Service Campaign ID: 76 – 01 Solis Poptop

Issued Date: July 1, 2026

On certain Winnebago vehicles with Winnebago manufactured poptops (60A & 60C), incorrect rivets may have been used during poptop assembly and the poptop overhead brackets may have misaligned rivet holes.

Step 1: Access and Reinforce Retention Belt Mounting Bracket

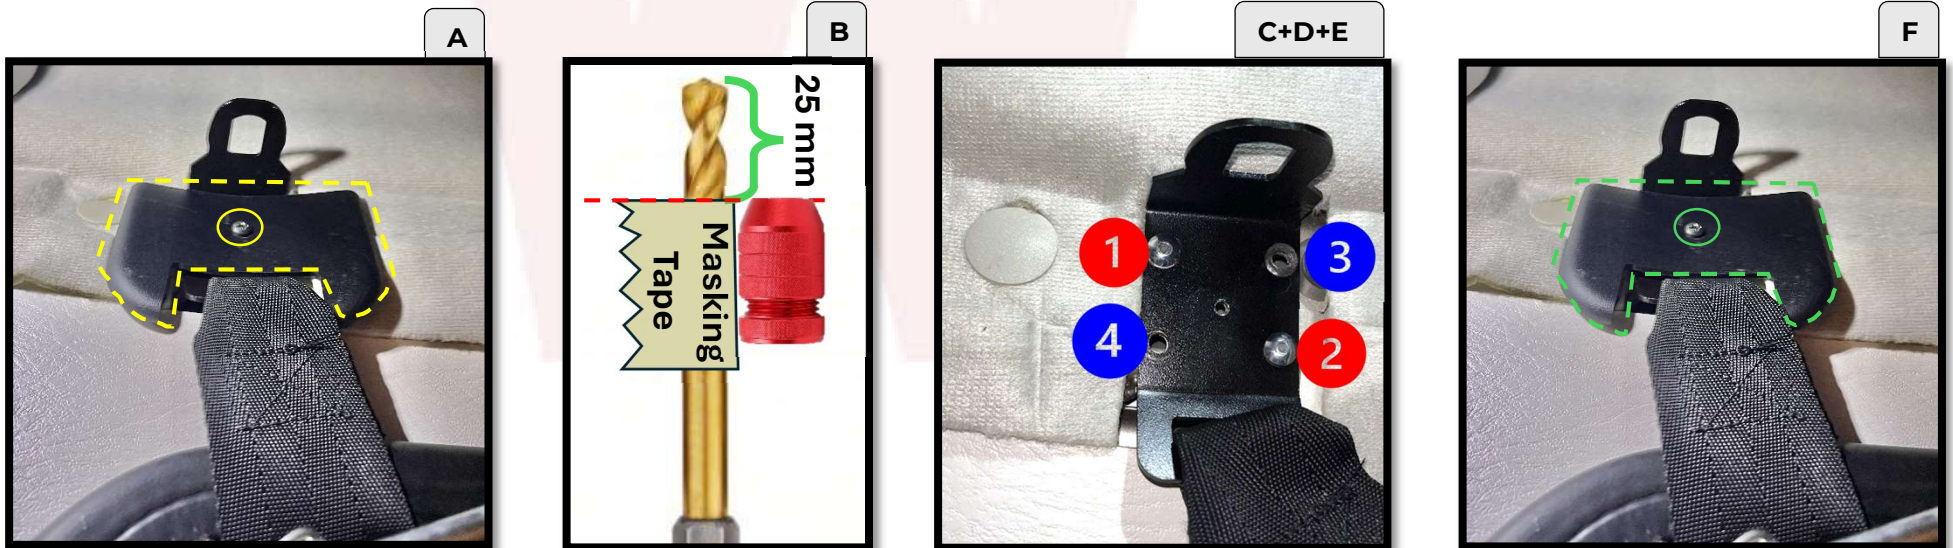
- A. Remove the trim piece cover on the LH belt using a #2 Philips bit and driver to access the retention belt mounting bracket.
- B. Use a drill stop (preferred) or masking tape to mark the 3/16" drill bit at 25 mm to avoid drilling too deep and damaging the van roof.
- C. Use a right-angle drill with a 3/16" bit to drill out 2 existing rivets on opposite corners of the bracket.
- D. Install two 3/16" rivets (16366401-01A) using a rivet gun in place of the 2 removed rivets.
- E. Repeat the process for the remaining two rivets.
- F. Reinstall the trim piece cover for using the #2 philips bit and drill.
- G. Perform Step 1 A - F procedure on the RH Belt Bracket.

Step 4 - Remove Poptop Upper Bracket (LH)

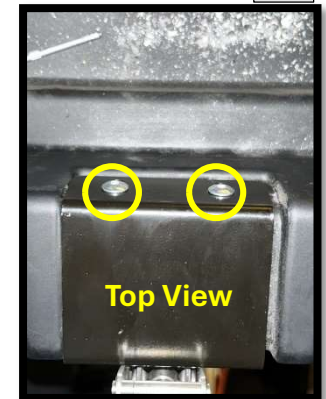
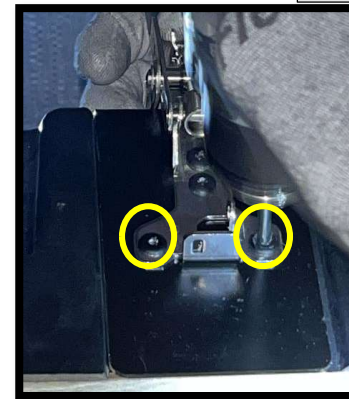
- A. Use the 3/16" bit and drill to drill out both the 2 rivets on the front side (securing the latch mechanism)
- B. Use the same 3/16" bit and drill to drill out the 2 rivets on the backside side of the LH Upper Bracket.
- C. Remove this bracket from the assembly and discard it appropriately.

Step 5 - Remove Poptop Lower Bracket (LH)

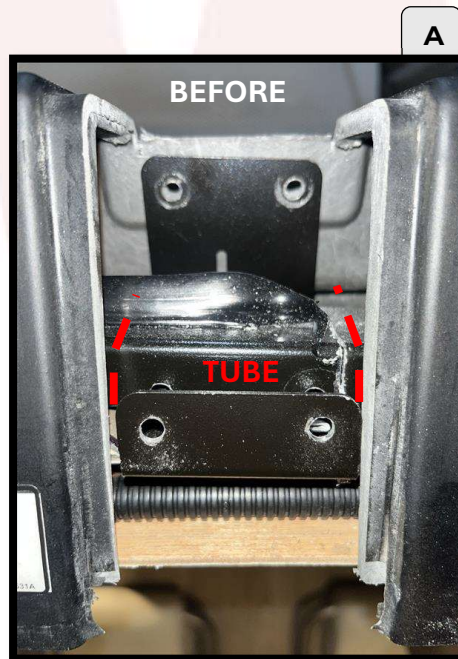
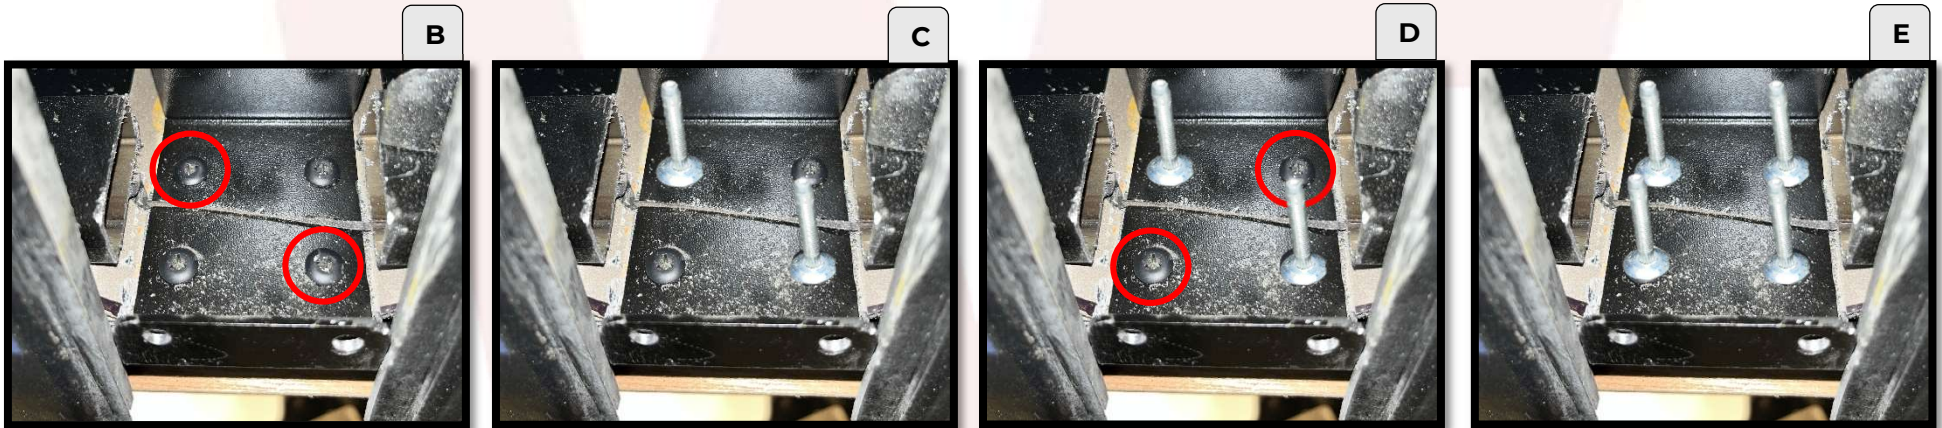
- A. Use a Sawzall with a 4-inch blade to cut through the existing tube (**tube only**) that runs horizontally over the base of the LH Lower Bracket. The cut must be flushed with the trim opening edges.

- B. Using the marked 3/16" drill bit, drill through 2 (opposing corner rivets) of the 4 existing bracket base rivet holes of the lower bracket. Then enlarge the 2 holes with the 1/4" inch bit. **Ensure you do not exceed the 35 mm of depth to prevent damaging the ceiling liner.**

- C. Prefit (**don't' install**) 2 of the new 1/4" rivets from the kit unto the 2 holes you drilled out with the 17/64" drill bit.
- D. Using the same 3/16" drill bit, drill through the other 2 (opposing corner rivets) of the 4 base rivet holes in the lower bracket. Then enlarge the 2 holes with the 1/4" inch bit. **Ensure you do not exceed the 35 mm of depth to prevent damaging the ceiling liner.**

- E. Prefit (**don't' install**) 2 of the new 1/4" rivets from the kit unto the 2 holes you drilled out with the 17/64" drill bit.
- F. Once you secured alignment of the holes, remove the new prefitted rivets to discard existing lower latch bracket.

DO NOT INSTALL THE NEW RIVETS ON THIS EXISTING BRACKET.

PRE-FITTING THE RIVETS IS ONLY TO ENSURE THE HOLES ARE ENLARGED IN THE APPROPRIATE LOCATIONS FOR THE NEW LOWER BRACKET.

Step 6 – Install New Lower Bracket (LH)

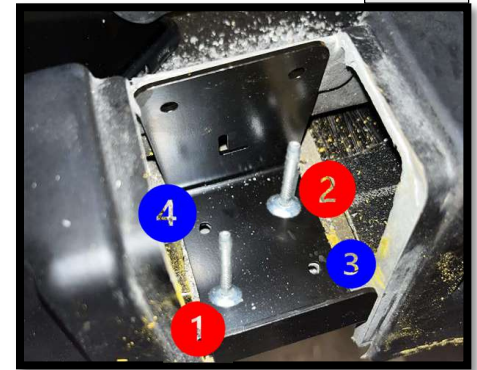
- A. Place the new LH Lower Latch Bracket from the kit where the existing lower bracket was removed from and align it on the 4 newly enlarged holes you created and prefit 4 1/4" inch rivets from the kit.
- B. Once the bracket and holes are properly aligned, use the rivet gun to install the rivets in an opposing-corner pattern and discard any rivet mandrels broken off after installation.

Step 7 - Upper Bracket and Latch Installation (LH)

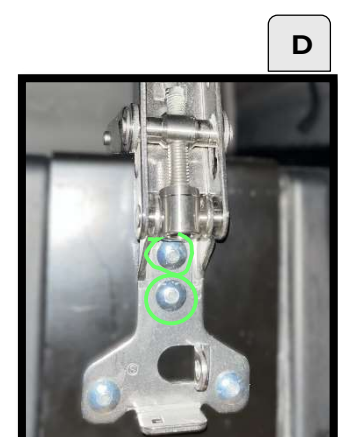
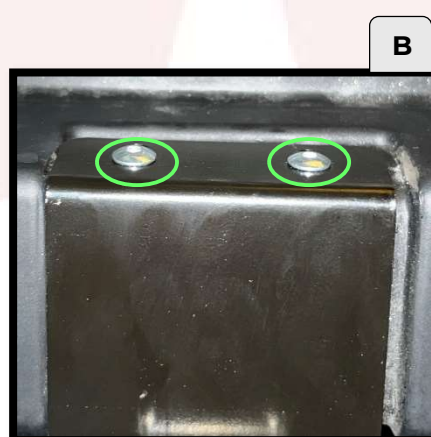
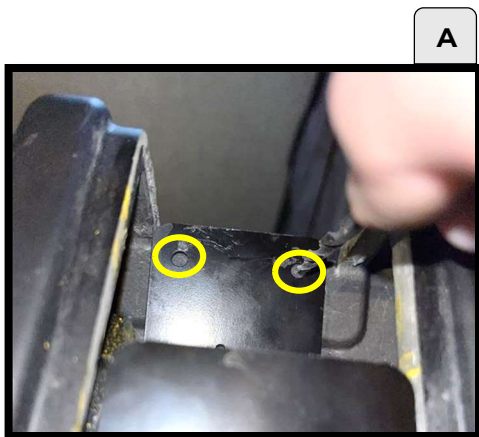
- A. Using a 17/64" drill bit, predrill two new holes on the upper rearward side of the lower bracket. Drill through the bracket and fiberglass, using the existing holes in the lower bracket as the guide for the new rivet holes.

- B. Align 1 of the upper brackets from the kit over the drilled holes and insert a 1/4" rivet into each HOLE. Use a rivet gun to secure them, locking both brackets and the fiberglass together.

- C. Using the same 3/16" drill bit and drill, predrill the 2 holes found on the latch's side flanges, though the upper bracket and through the newly installed lower bracket's flange. Once holes are created, install 2 of the 3/16" rivets through these holes.

- D. Once the latch is secured, install 2 of the 3/16" rivets through the center holes of one of the latches provided in the kit to secure the new latch properly on the upper bracket. Use a shop vacuum to clean any residual particles.
